# Replacement Notes for : Tan America

## Installations Notes:

Typical Applications:  
Tan America

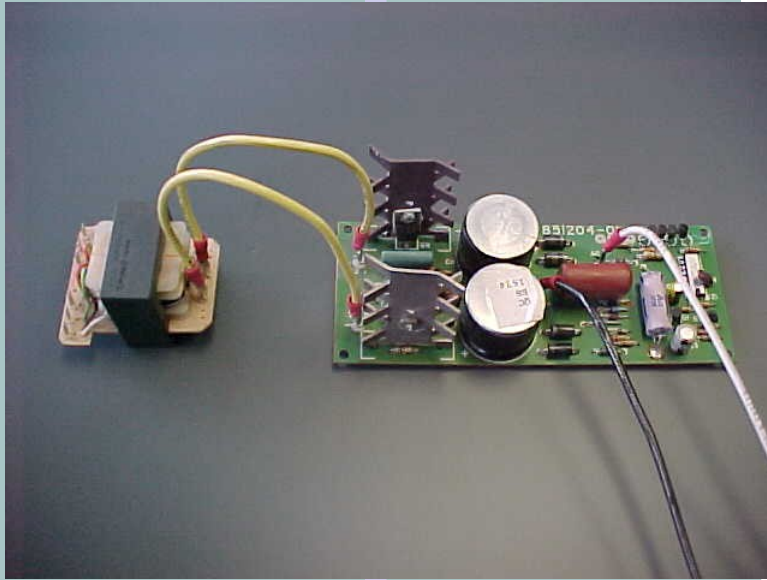
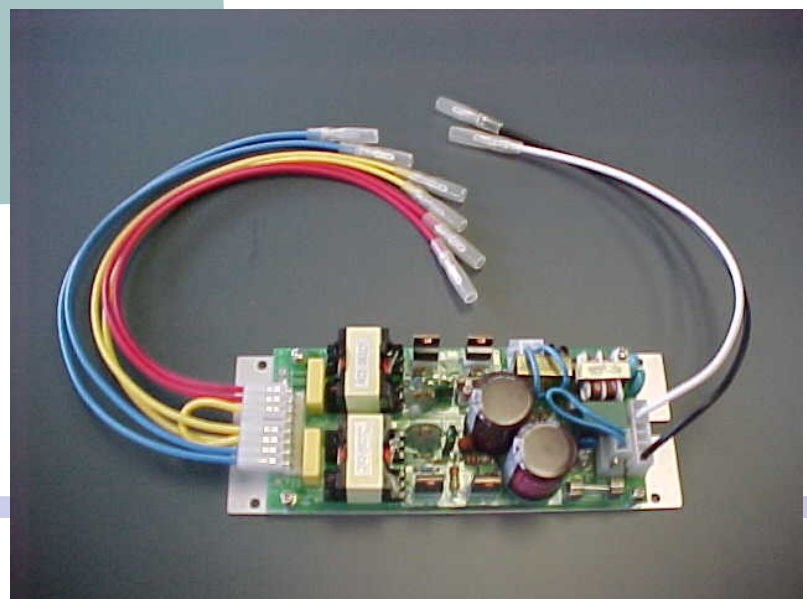
Tan America ballast with transformer, pictured at left, is replaced by the FA100 ballast using adapter harnesses 2-6IN-220-TA for the input and 7-8OUT-TA for the output, as pictured below. The old external transformer is no longer needed. Move both input voltage selectors on the FA100 to 220-volt mode. Note on some Tan America units that the ballast may be in a ballast tray and the transformer in the canopy or bench.
